Planning Officer: Lynnyrd Wolfe

Planning Application Ref: BN/114/19/T

Location: Shannock, Church Lane, Eastergate, PO20 3UT

Description of works: Crown reduction up to 2m to growth points to 1no. beech tree

Figure 2 Positions of final cuts

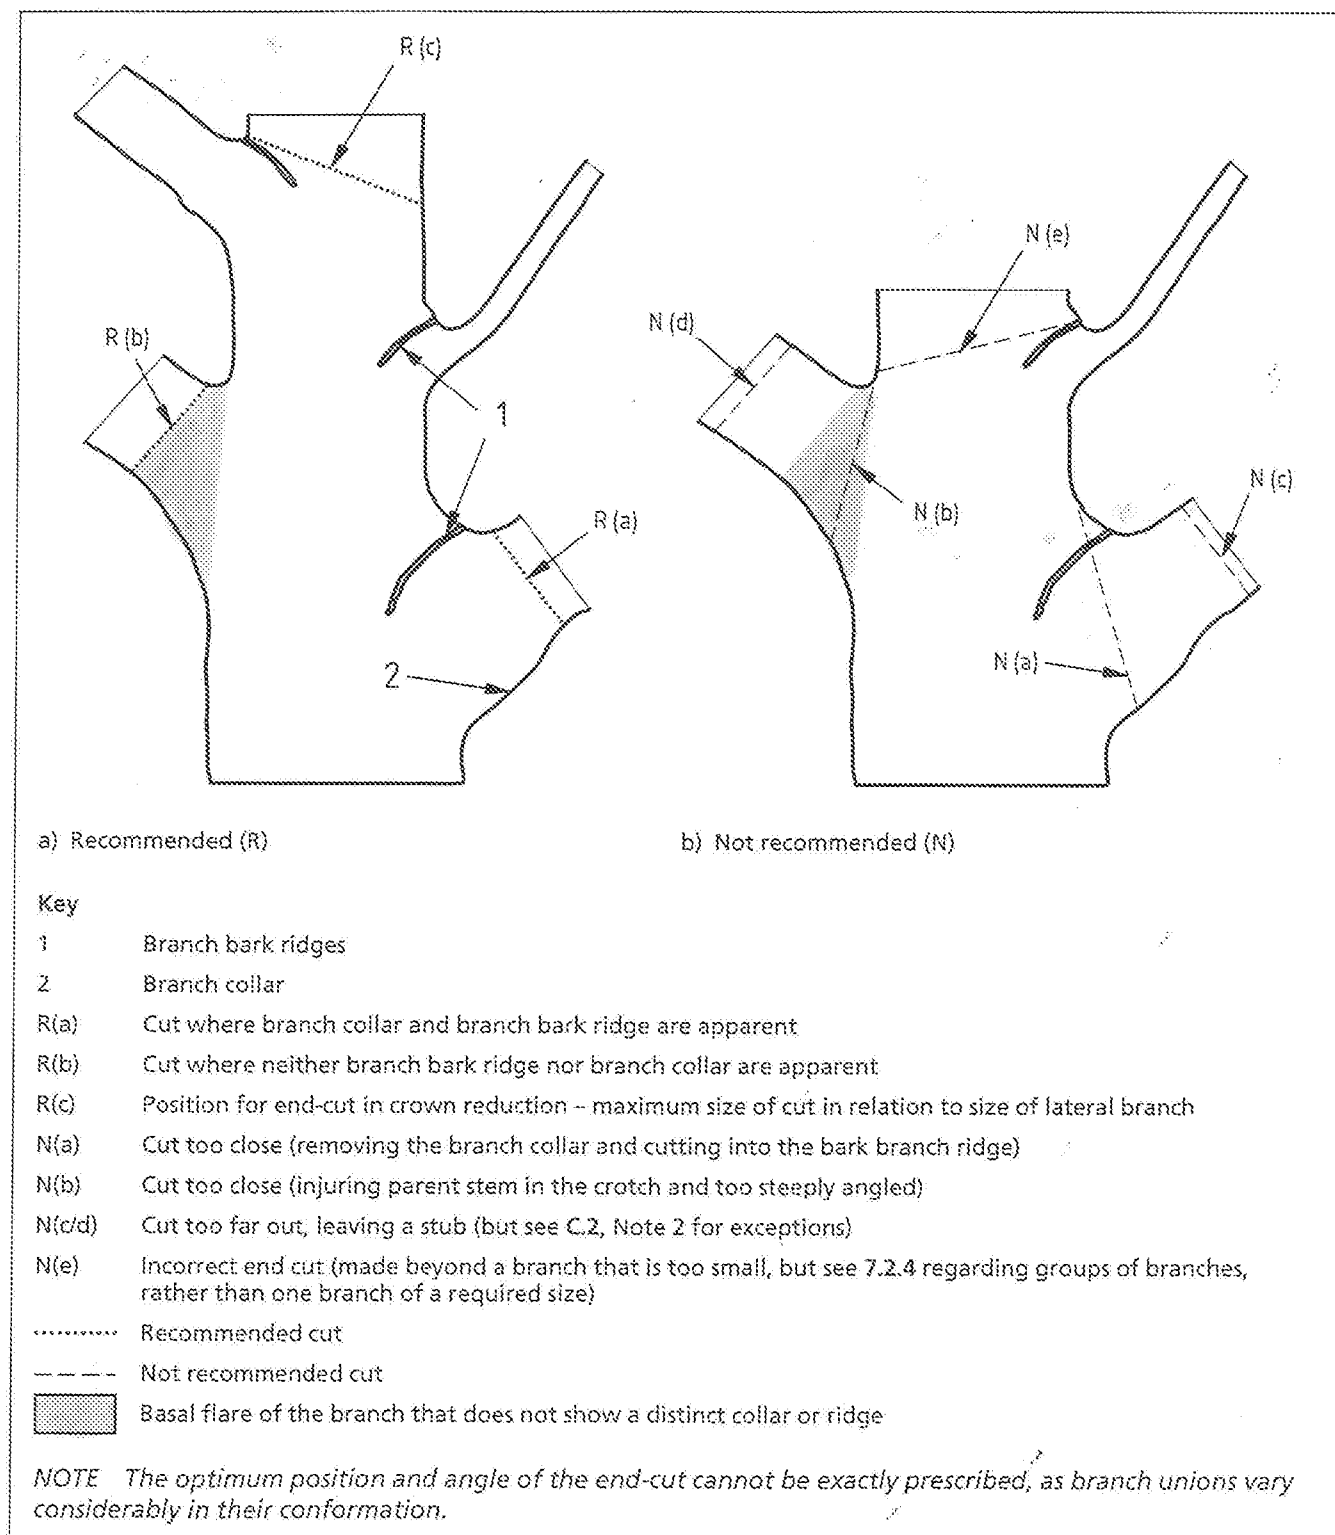
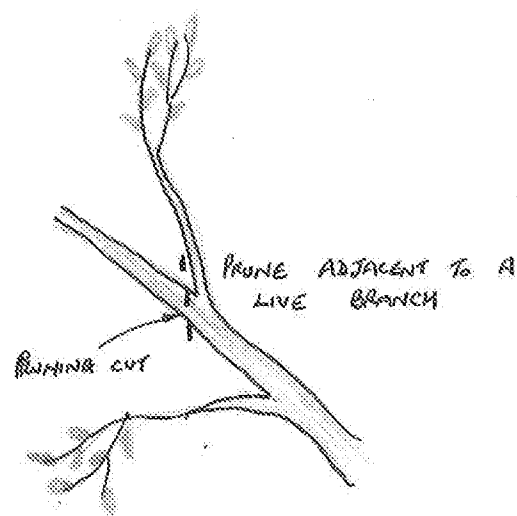
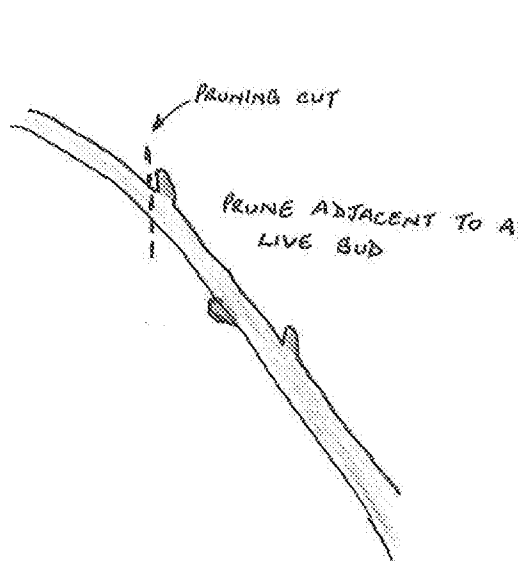
Part a) Where whole branches are to be removed and final cuts made close to the trunk or branch union they are to be made as shown in Figure 2 of BS3998:2010

Figure 3 Crown lifting

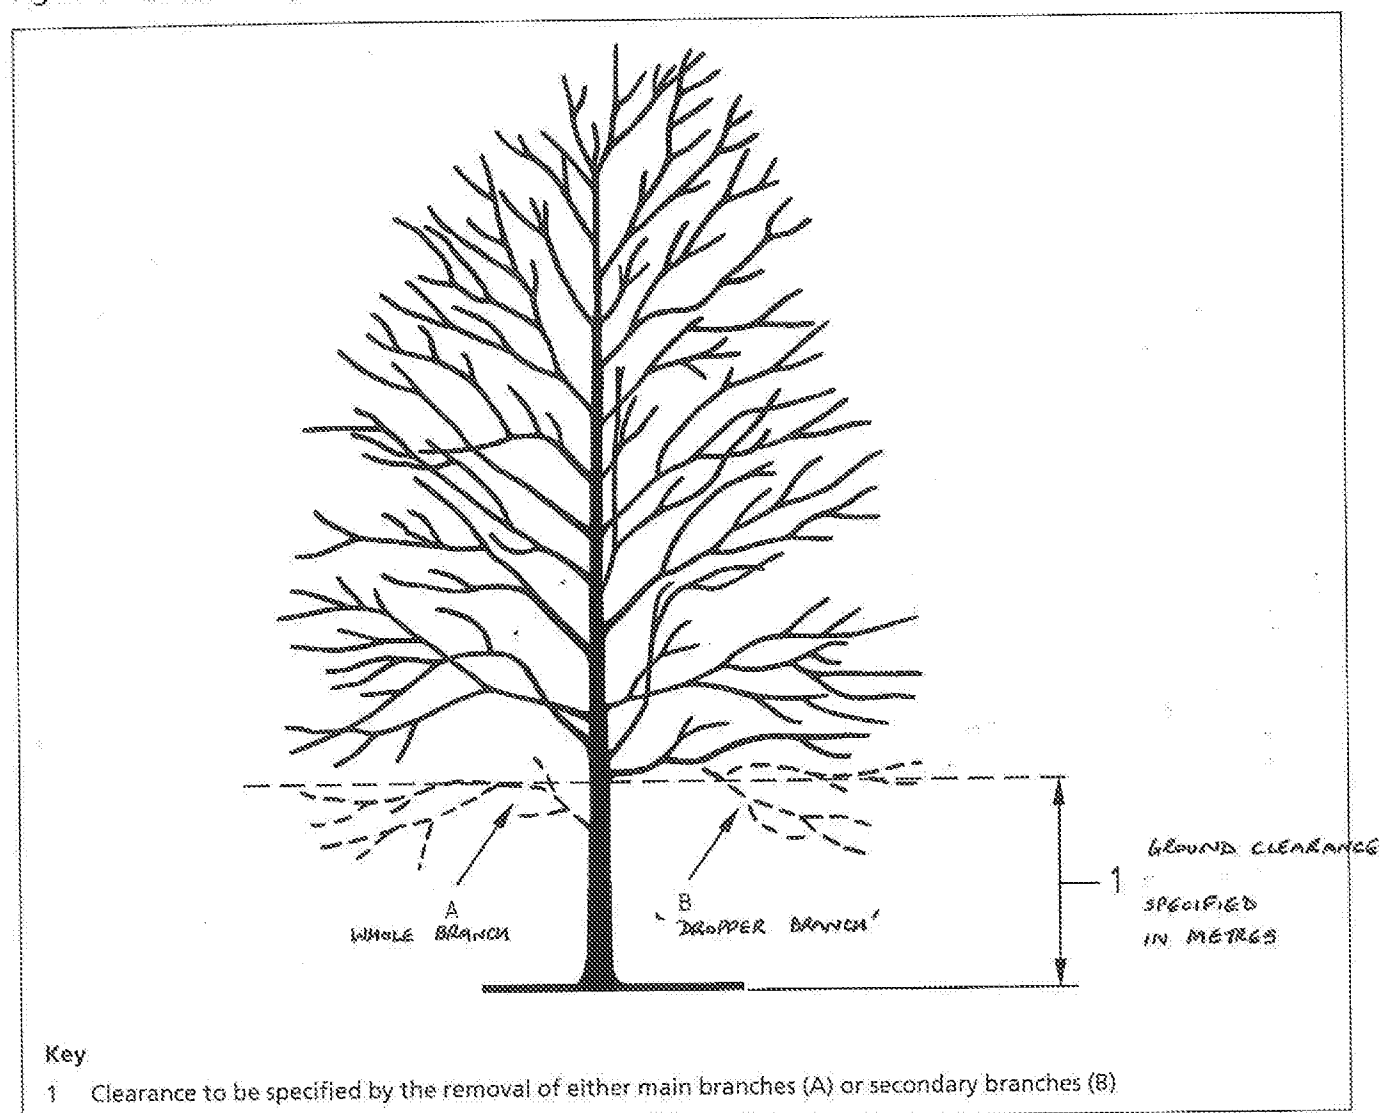
- I would like to see the applicant submit a revised work specification such as detailed below, which would address some of their concerns whilst preventing a diminution of the tree's landscape and public amenity value:
 - Crown lift (careful selection of 'main' and 'secondary' branches) to provide 3m overhead clearance on all aspects
 - Crown lift (careful selection of 'main' and 'secondary' branches) to provide 6m overhead clearance above carriageway
